Subject: Casey Arborway Project Bicycle Facilities

LivableStreets Alliance is pleased to submit this comment in reference to the proposed Casey Arborway Project Bicycle Facilities.

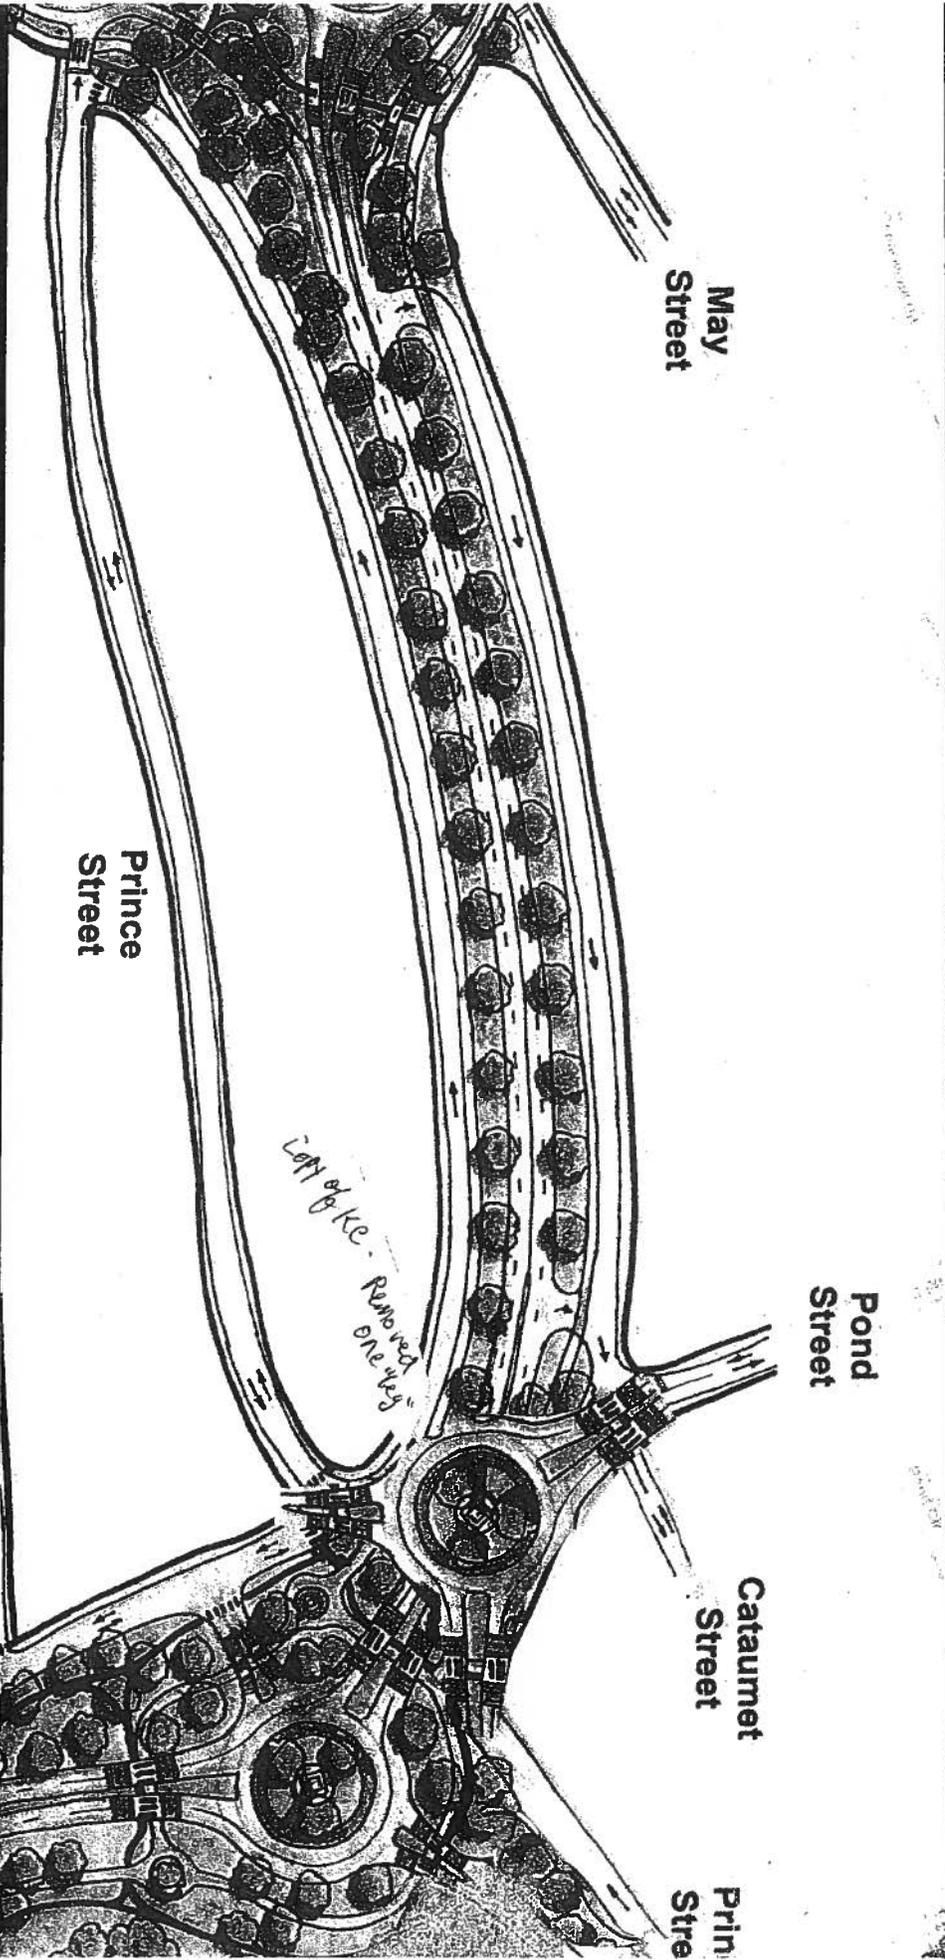
The Murray Circle double roundabout is a new idea, and while many embrace it, some will need to see how it can work. This seems quite achievable.

In contrast, by far, the most concern and negative feedback has been about the Kelley Circle end of the project, specifically on the Moss Hill (western) side including Pond St., Prince St. & Parkman Drive, the "3 P's".
